BIDDING ADDENDUM NO. 1

**CATAWBA COUNTY CATTLEMEN'S ASSOCIATION
EDUCATION CENTER
NEWTON, NORTH CAROLINA
CBSA Project 2024.008
August 24, 2026**

A1.0

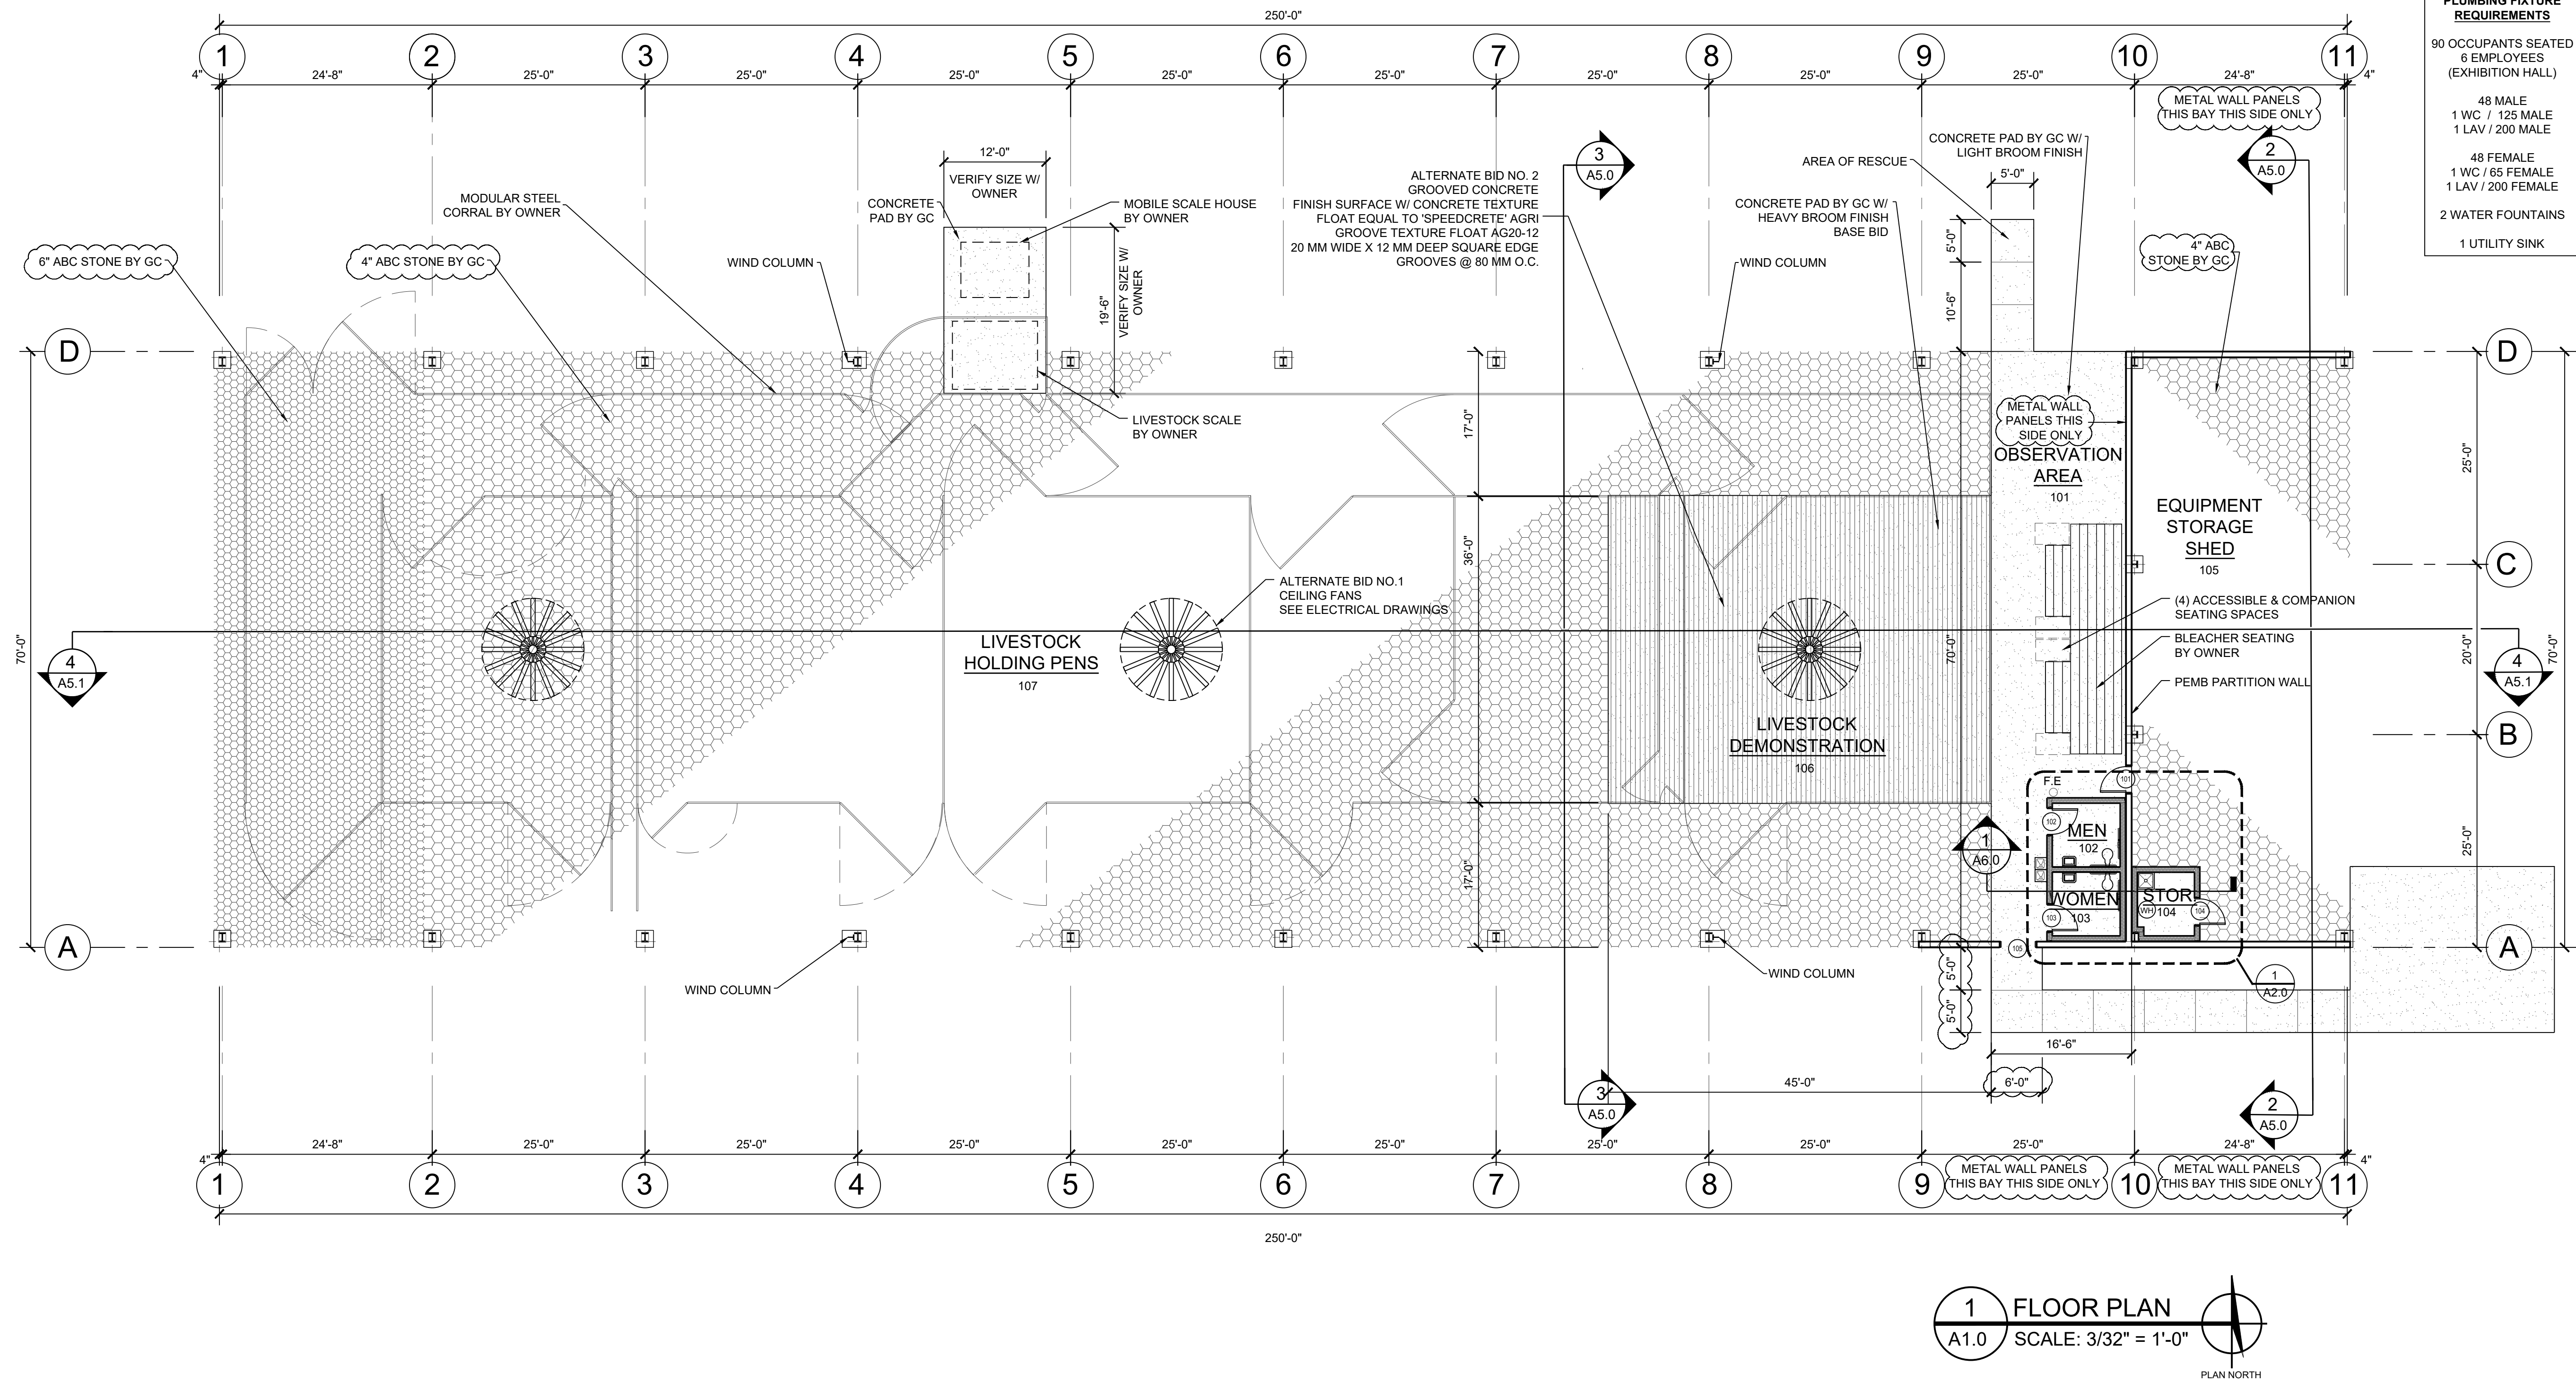
8. 6" ABC stone shall be provided by GC between column lines 1 and 2. See attached drawing.

9. 4" ABC stone shall be provided by GC in all other exposed ground cover areas within Livestock Holding Pens 107 and Equipment Storage 105. Stone specified under concrete slabs shall remain as indicated on drawings. See attached drawing.
10. Concrete walk is modified to be 5'-0" wide and moved 5'-0" away from south building wall. 6'-0" wide walk shall be provided leading into building from the 5'-0" walk. See attached drawing.
11. Metal wall panels are indicated to be on one side of wall between column lines A/9-A/11, D/10-D/1, and A/10-D/10. See attached drawing.

1 LIFE SAFETY PLAN
BC1.1 SCALE: 3/32" = 1'-0"

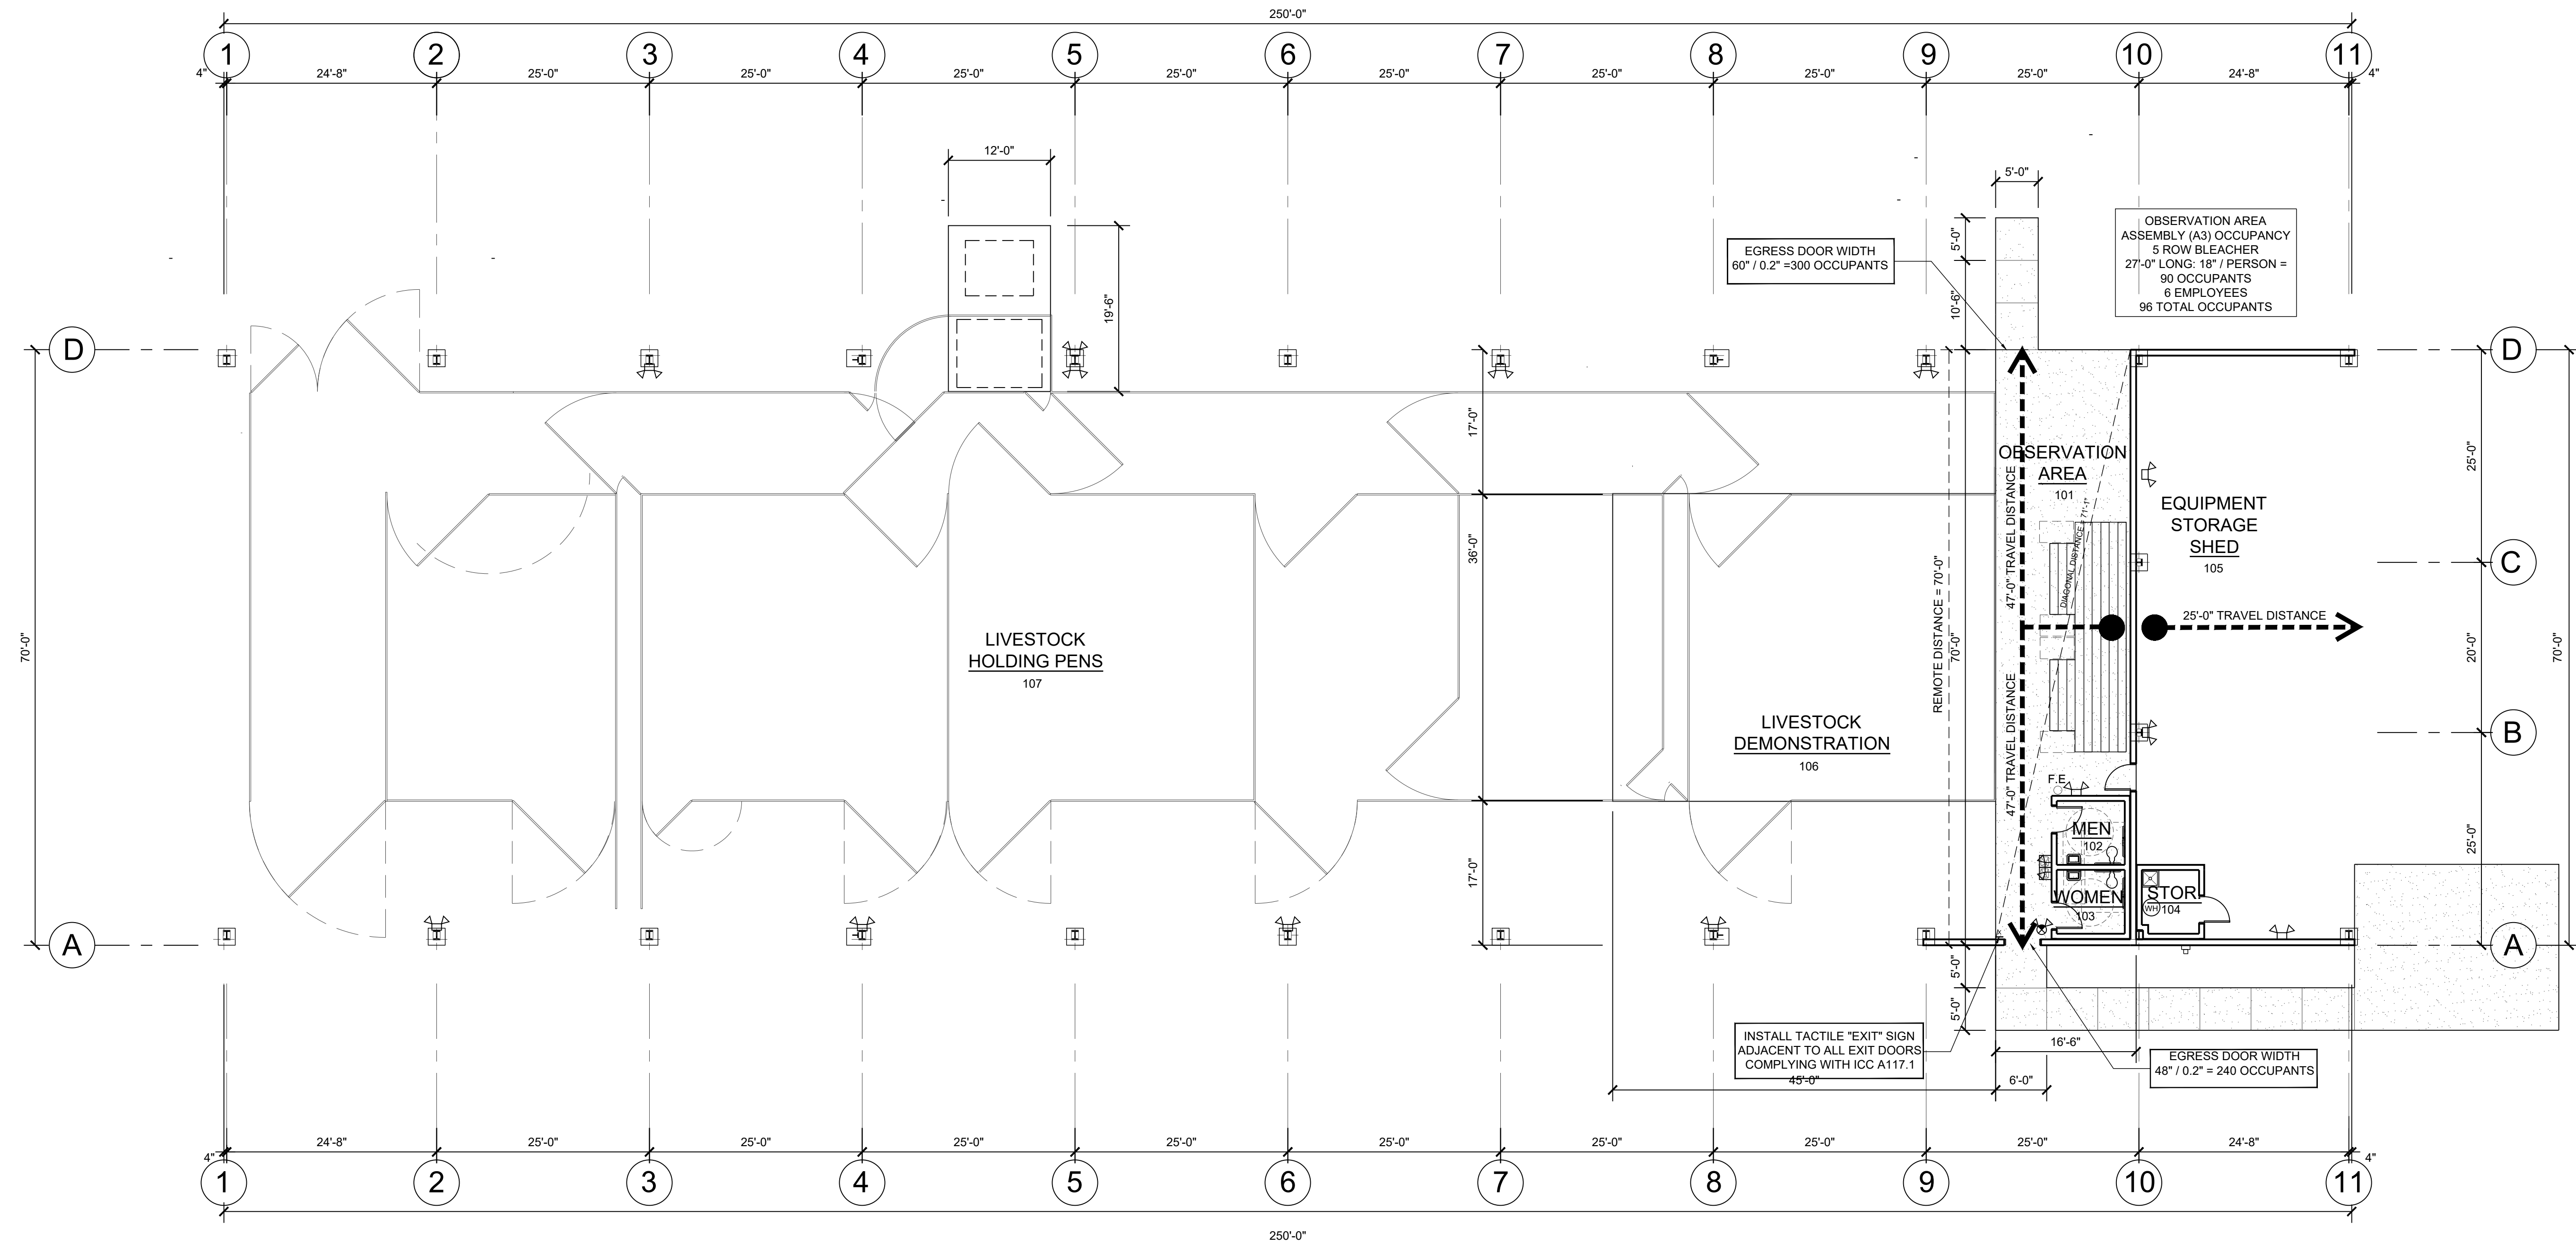
2. Life Safety Plan is modified to omit stone hatching to reduce confusion. See attached drawing.

7. Life Safety Plan is modified to omit stone hatching to reduce confusion. See attached drawing.

A4.0

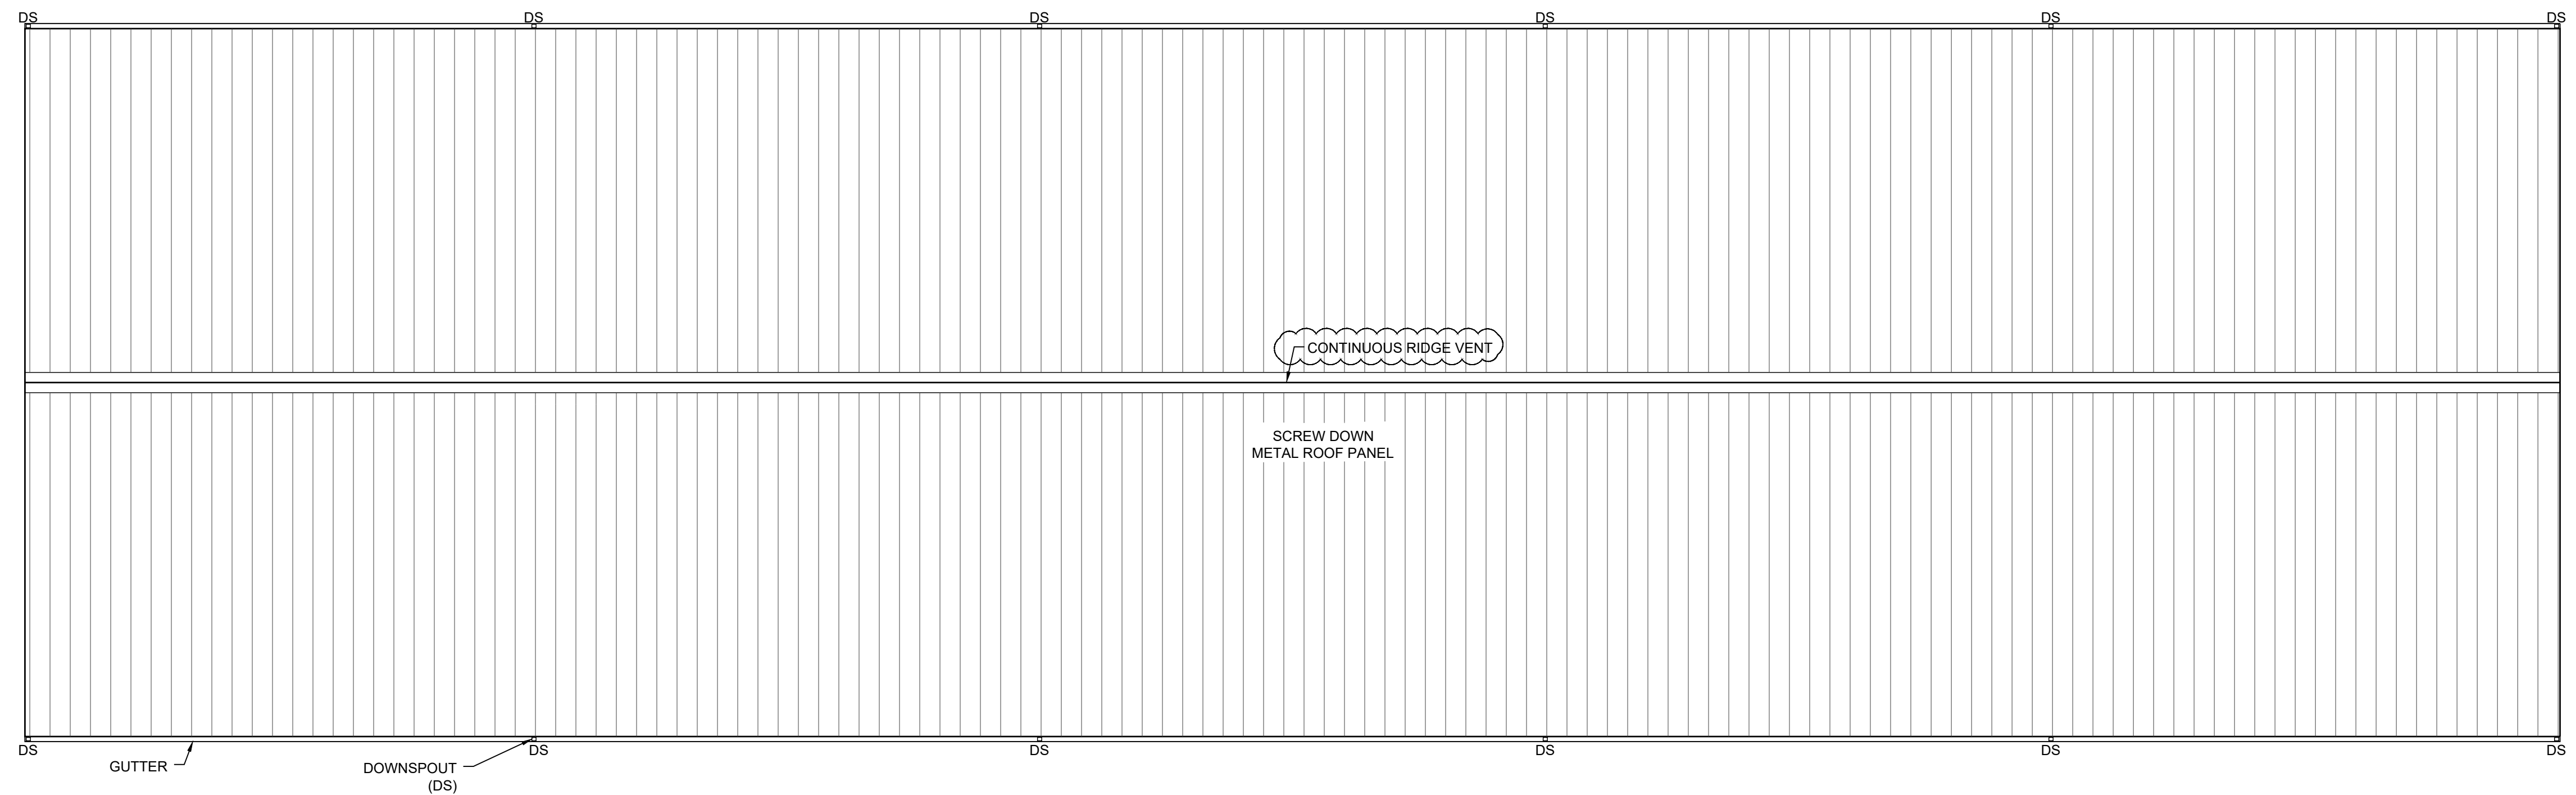
12. Modify roof ridge to be ridge vent. See attached drawing.
